**RE: Wastewater Treatment Improvements
Wessington Springs, South Dakota
SPN #16790**

ADDENDUM NUMBER 1

Plan Sheet 34

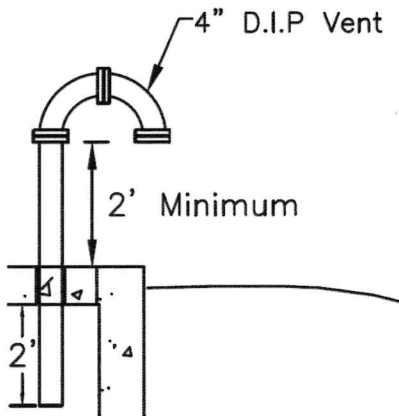
The ductile iron vent pipe and fittings shall be revised with the following details.
